# Sumitomo/ExceLight

Reach Feasibility of 1550nm DML for  
10G and beyond

December 06

# Optical Waveform of 1550nm DFB-LD - 10.3Gbps, ER=5dB, 25deg.C -

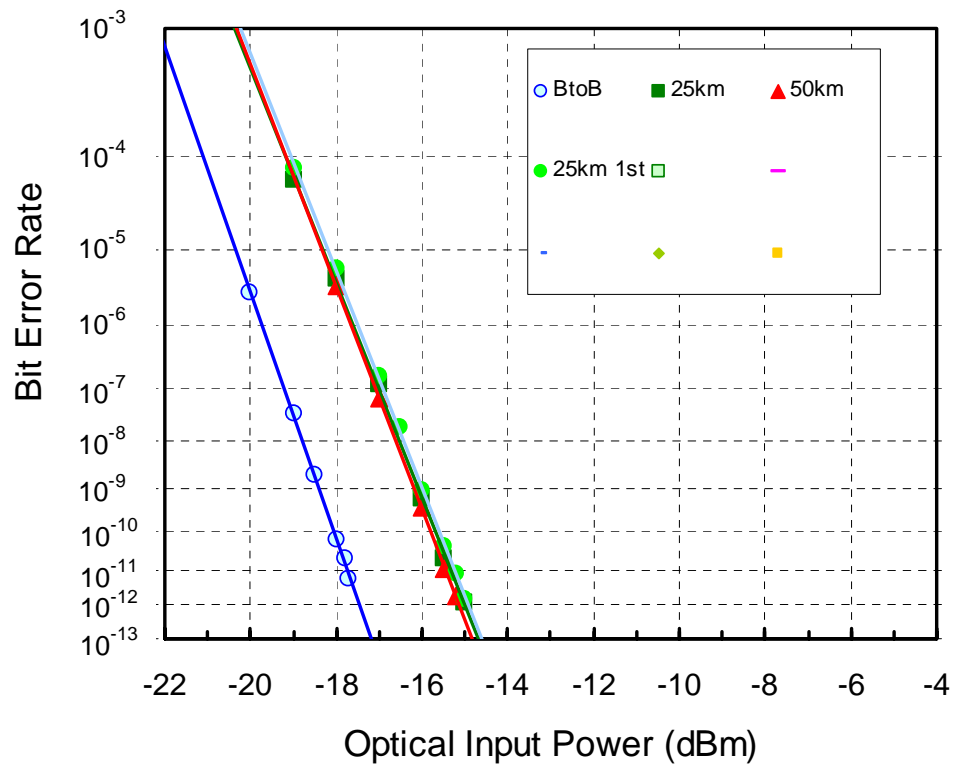
Keeping enough eye opening up to 800ps/nm
